UNITED STATES PATENT AND TRADEMARK OFFICE

APPLICATION NO.	FILING DATE	FIRST NAMED INVENTOR	ATTORNEY DOCKET NO.	CONFIRMATION NO.
10/550,271	09/23/2005	Hiroyasu Yumura	017700-0177	1269
22428 7590 02/05/2007 FOLEY AND LARDNER LLP SUITE 500 3000 K STREET NW WASHINGTON, DC 20007			EXAMINER SOON, SHELDON STEWART	
			ART UNIT	PAPER NUMBER
			2809	
SHORTENED STATUTORY PERIOD OF RESPONSE		MAIL DATE	DELIVERY MODE	
3 MONTHS		02/05/2007	PAPER

Office Action Summary

DETAILED ACTION

Figures 3 and 4 taken from Snowden

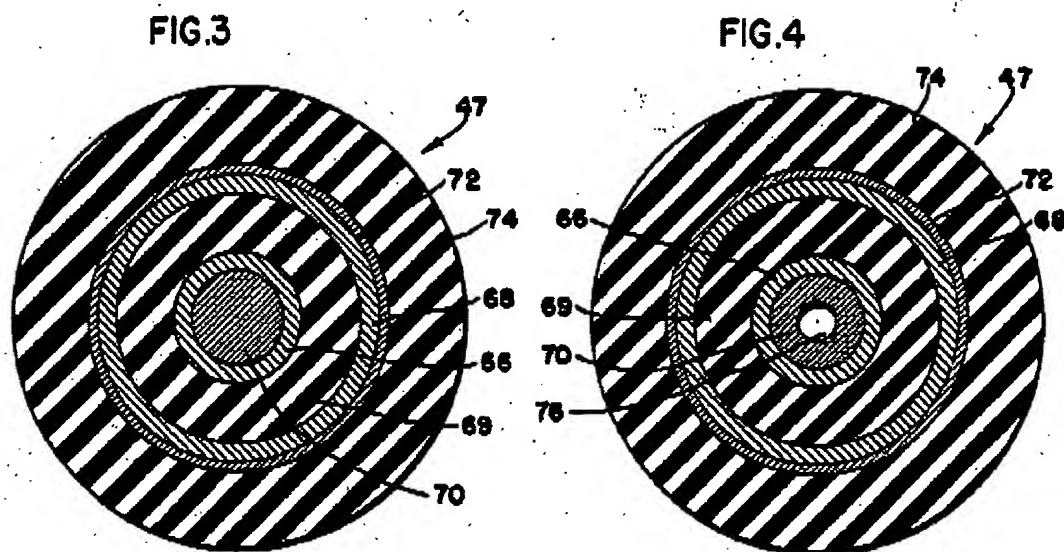
11. Claim 1 – Snowden discloses all the elements of the instant invention including, a superconducting cable (column 2 line 22), a former made of a normal-conducting metal (column 4 lines 18-22, item 70 above), a first superconducting layer (column 3 lines 71-73, item 66 above), an electrical insulation layer (column 4 line 1, item 69 above), and a second superconducting layer (column 3 lines 71-73, item 68 above). Snowden fails to show a normal conducting metal layer formed between the insulating layer and the second superconducting layer. Snowden does however show a normal conducting metal layer outside the second superconducting layer (column 4 lines 18-22, item 72 above). It would have been obvious to one having ordinary skill in the art at the time of the invention to exchange the position of the second superconducting layer with the normal conducting layer, since it has been held that a mere reversal of the essential working parts of a device involves only routine skill in the art. In re Einstein, 8 USPQ

16. Claim 4 – As best understood by the examiner (see previous objection), Snowden in view of Perez discloses all the elements of claims 1 and 3 of the claimed invention. Snowden further discloses the use of an insulating layer (item 74 in figure 3)

Figure 1 taken from Perez

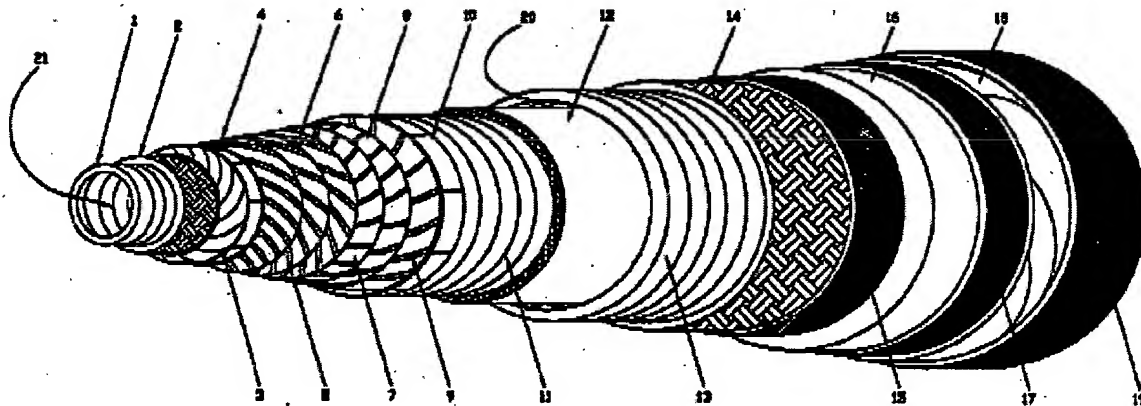
15. Claim 3 – Snowden discloses all the elements of claim 1 of the claimed invention, but fails to disclose the normal-conducting metal layer is formed by winding round wires with around cross section or tape-shaped wires formed from a normal-conducting metal. Perez teaches the use of a layer of wrapped copper tape (item 3 in figure 1). It would have been obvious to someone of ordinary skill in the art at the time of the invention to use the wrapped conducting tape method of Perez in the cable of Snowden since it was known to be an economical method in lieu of other methods (i.e. sputtering, vapor deposition, electroplating, ect.).

17. Claim 5 - Snowden in view of Perez discloses all the elements of claim 1 and 3 of the claimed invention, but fails to disclose the normal-conducting metal layer has a multi-layer structure. Perez teaches the use of a multi-layer structure in items 1,2 and 3 in figure 1. It would have been obvious to one of ordinary skill at the time of the invention to use the multilayer normal-conducting metal layer of Perez in the cable of Snowden since Perez states in paragraph [0017], the steel mesh and tape help obtain a relatively flat surface (to lay the superconducting tape upon).
